Contents of Brief

- Location of proposed site
- Visibility from Picanoc and Mount O'Brien
- Type of soil and views of site
- Closeness of wetlands
- Liner problems as consequence of temperature allowance and soil differences
- Aquifer quality not proven by proponent
- Rock base not studied
- There are alternatives
- Project is not justified

FIGURE 1
 LOCALISATION ET DONNÉES DES TRAVAUX DE L'ÉTUDE HYDROGÉOLOGIQUE (LDC) ET HYDROGRAPHIE DU SECTEUR IMMÉDIAT

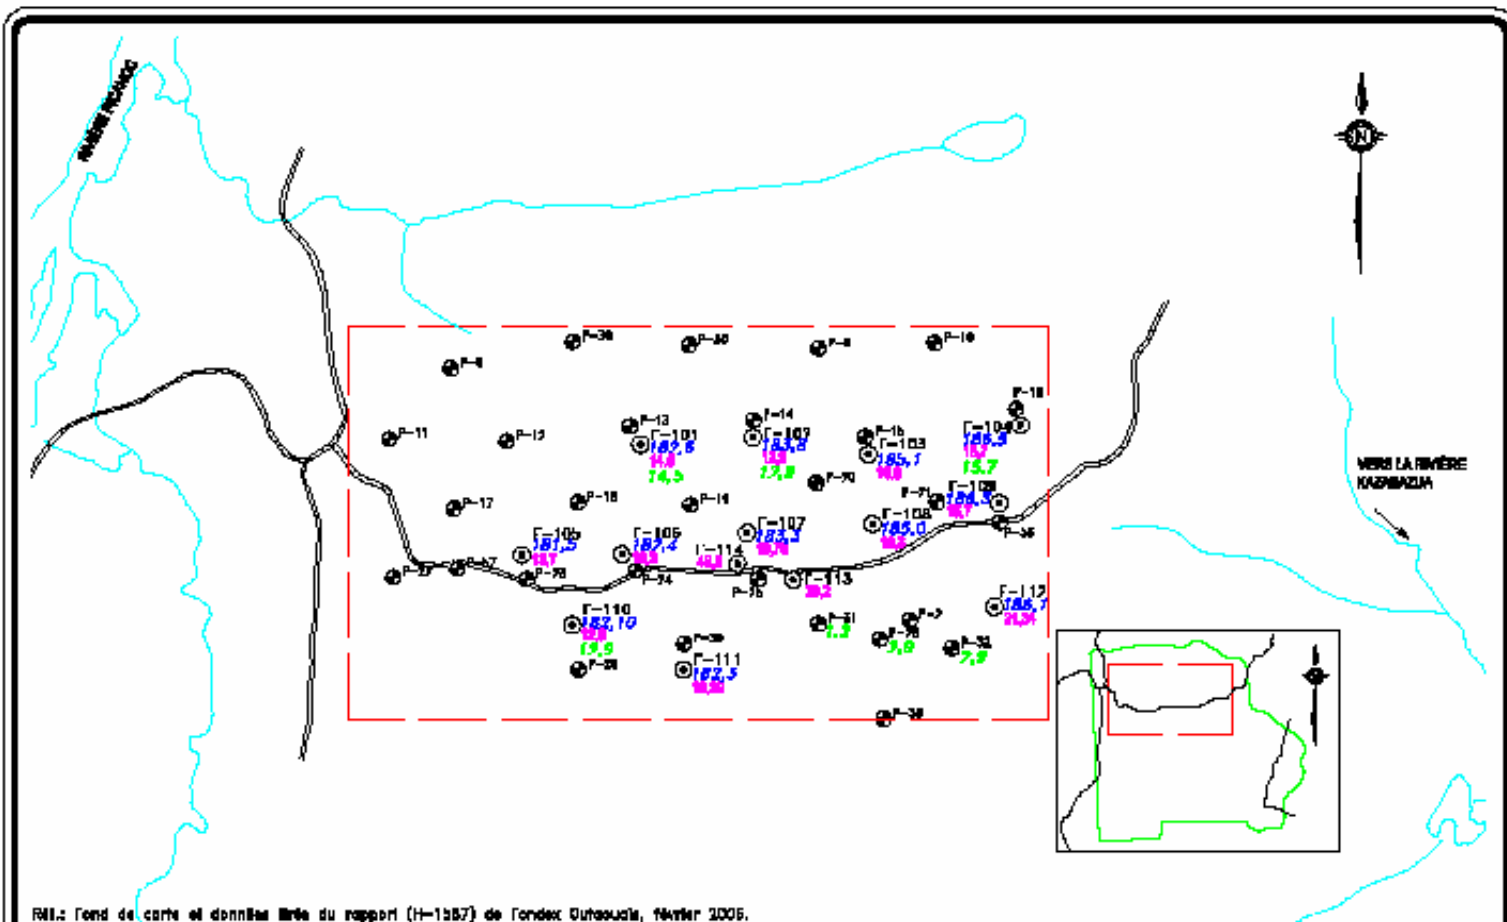
Shallow excavation in south-east sector showing water level
